Re: Building Permit Application No. 20-003 –Add/Alt to Residence
Forty Nine Dolphin Lane, Northport, N.Y. S:5 B:1 L: 27
Residence District A

INC. VILLAGE OF NORTHPORT
BOARD OF ZONING APPEALS
APPLICATION

PROJECT: KRAYDMAN RESIDENCE
49 DOLPHIN LANE
NORTHPORT, NY 11768

A RESOLUTION
IN CONNECTION WITH THE APPLICATION OF
VALERIY KRAYDMAN

SCHEMATIC PLOT PLAN

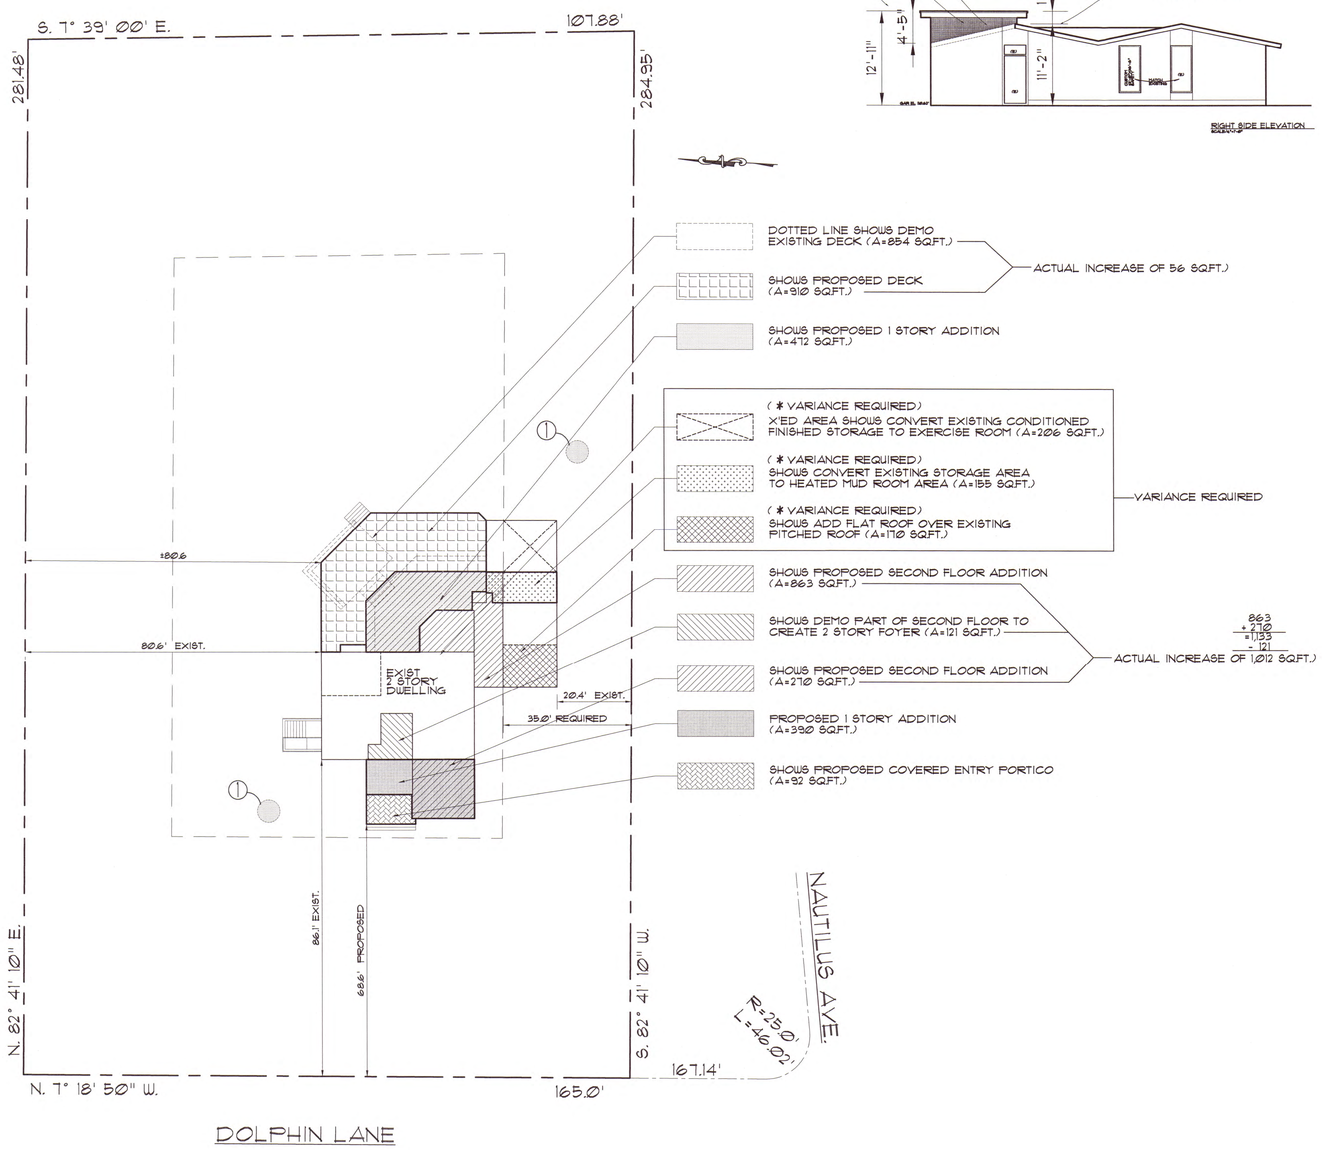
Your application for a building permit to construct an addition/alteration to the dwelling at the above-referenced property is hereby denied. Examination of the plot plan by Louise Agnes Architect P.C. & Associate dated 1/15/20 and survey by Seccafico Land Surveying dated 12/4/19 indicates this is a non-conforming lot specific to Lot Width and Side Yard Setback. The proposed construction would create a side yard of approximately 20.4' and therefore is an addition to an existing nonconforming side yard.

The proposed construction, therefore, would be in violation of the Code of the Village of Northport, Chapter 306, "Zoning," Section 306-22D (1) and Section 306-22H (1) in the Residence A District.

Section 306-22D (1): Minimum Lot Width 175ft. required to 165ft. proposed.
Section 306-22H (1): Side Yard Setback from 35ft. required to 20.1ft proposed.

* VARIANCE REQUIRED FOR ROOF CHANGE ONLY FROM SLOPED ROOF TO FLAT ROOF. EXTEND WALL UP TO UNDERSIDE OF NEW ROOF, ADD NEW GRAGE DOORS
